WELL NO. BUG #7 API NO. 43-037-30569

**APPLICATION FOR PERMIT TO DRILL, DEEPEN, OR PLUG BACK**

**SUNDRY NOTICES AND REPORTS ON WELLS**

(other) Corrected ownership lines on well location plat & area map & changed the property line distance

BUG WELL N° 7

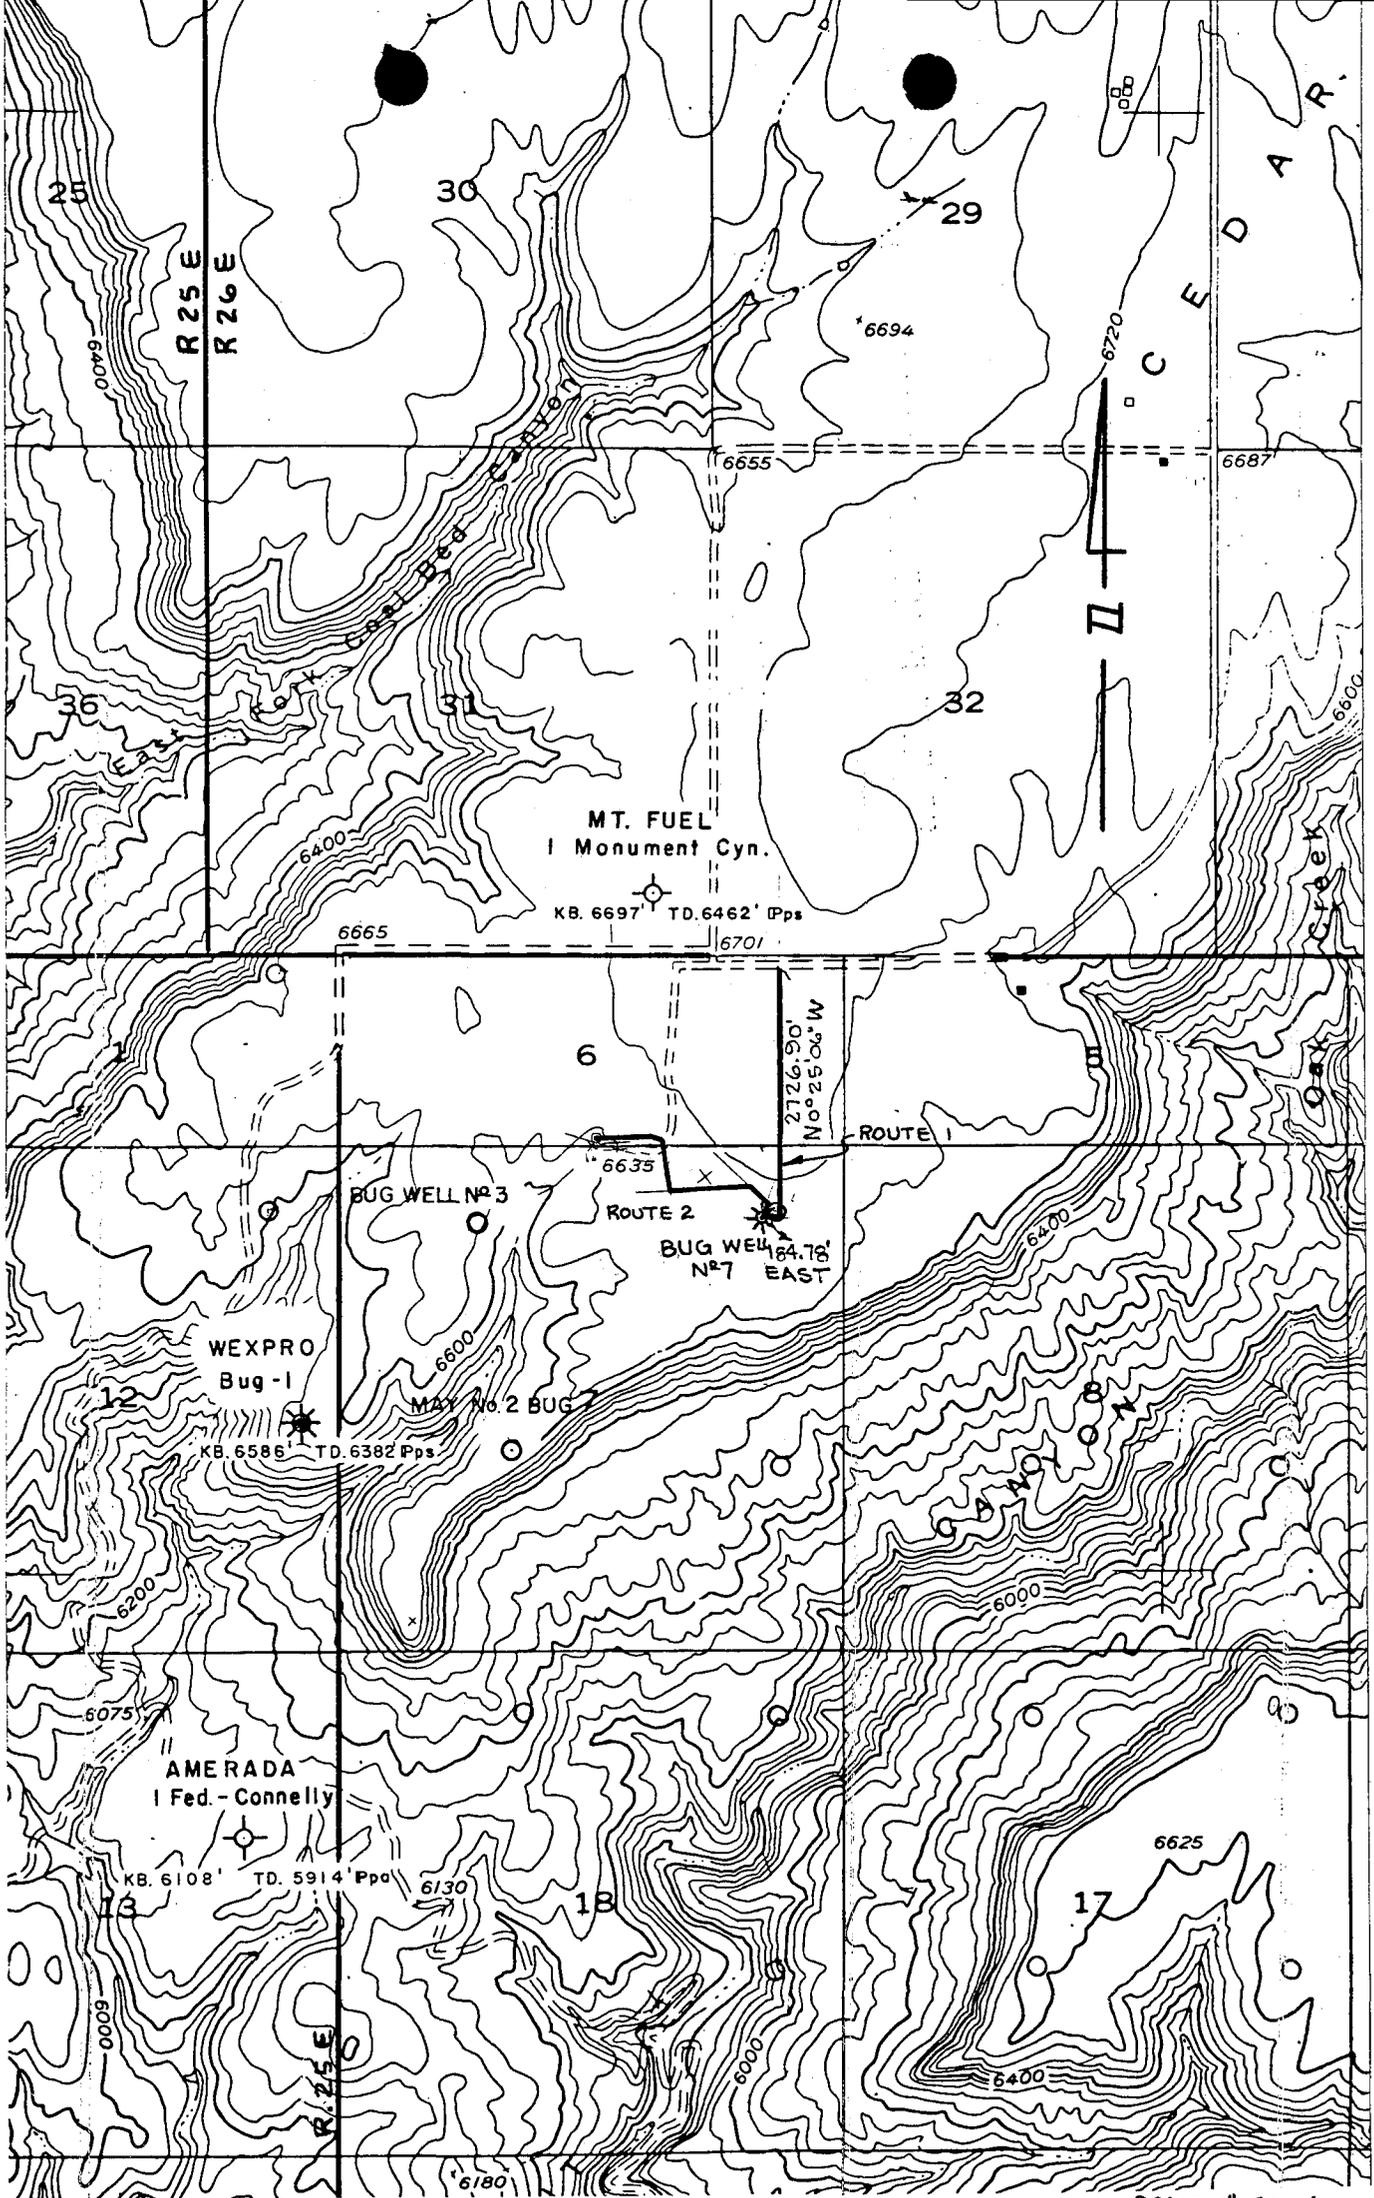
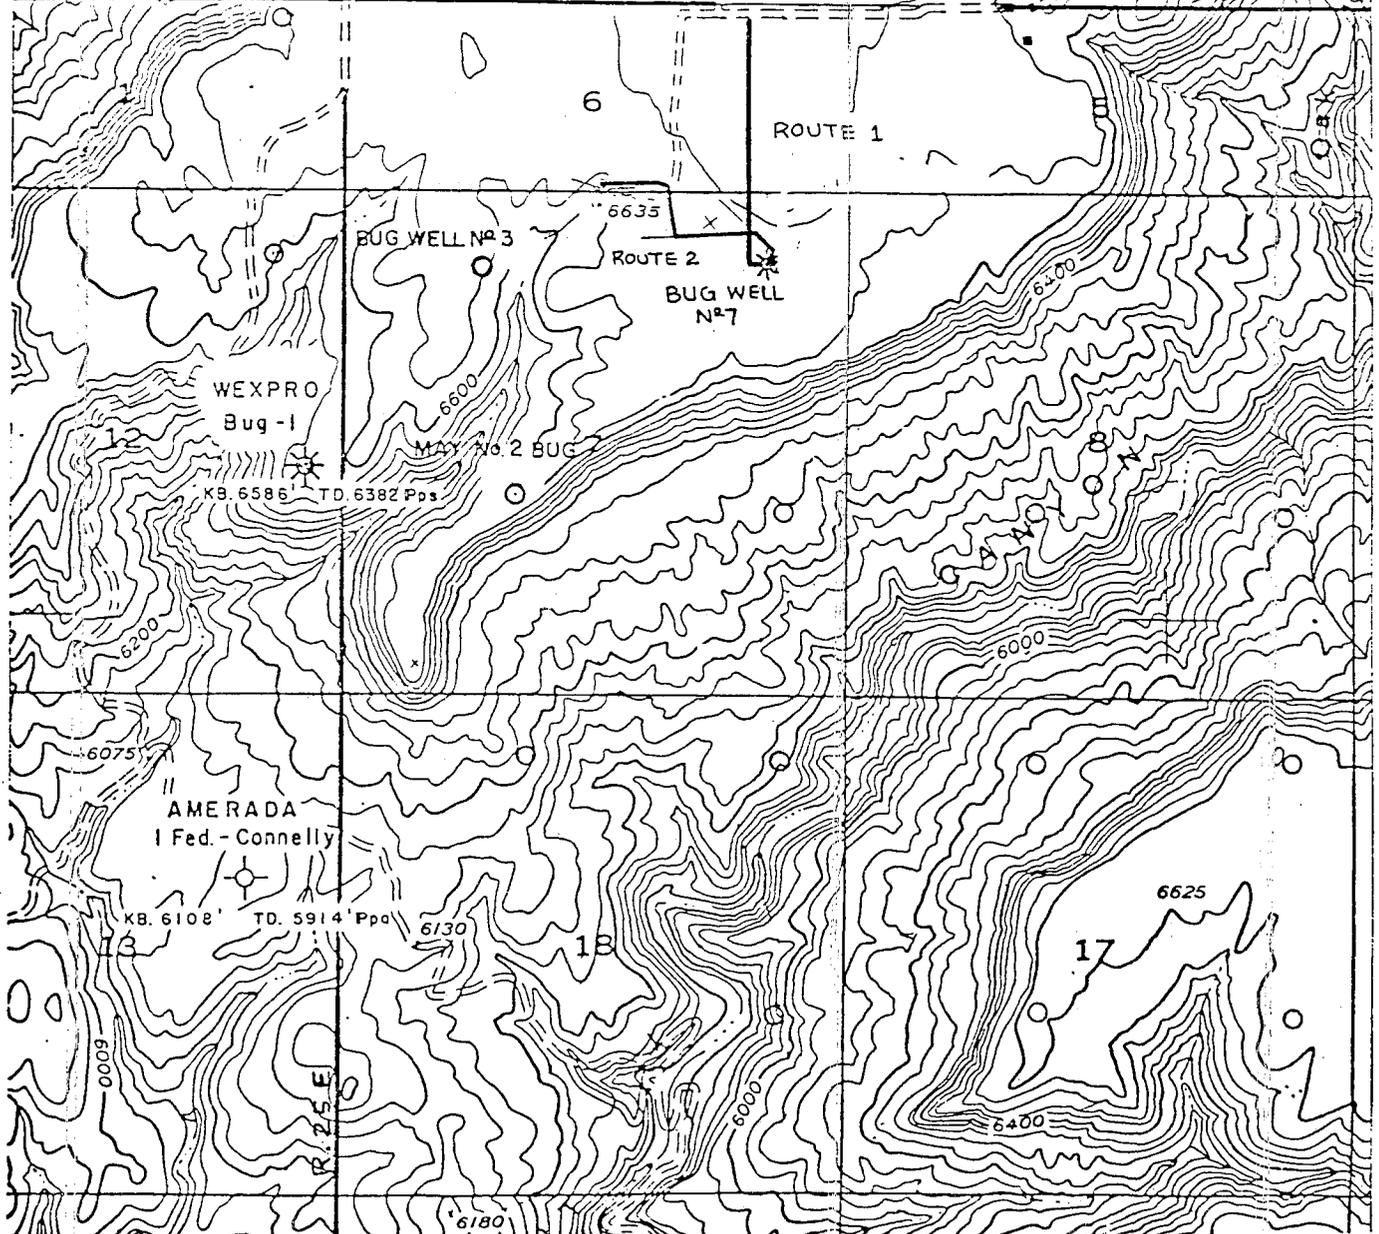
The well location plats attached were revised to show the corrected lease and ownership line. Also, the distance from the proposed location to the nearest property or lease line has been changed to 65 feet.

ROUTE 1  
 E WELL TO P.I. #1 - WEST 63.28'  
 P.I. #1 TO END - N 0° 25' 06" W 2726.90'

E WELL TO NE COR. SEC. 7  
 N 49° 18' 01" E 1114.71'  
 END ROUTE 1 TO NE COR. SEC. 7  
 S 24° 53' 56" E 2204.87'  
 END ROUTE 2 TO NE COR. SEC. 7  
 N 85° 58' 16" E 2654.77'
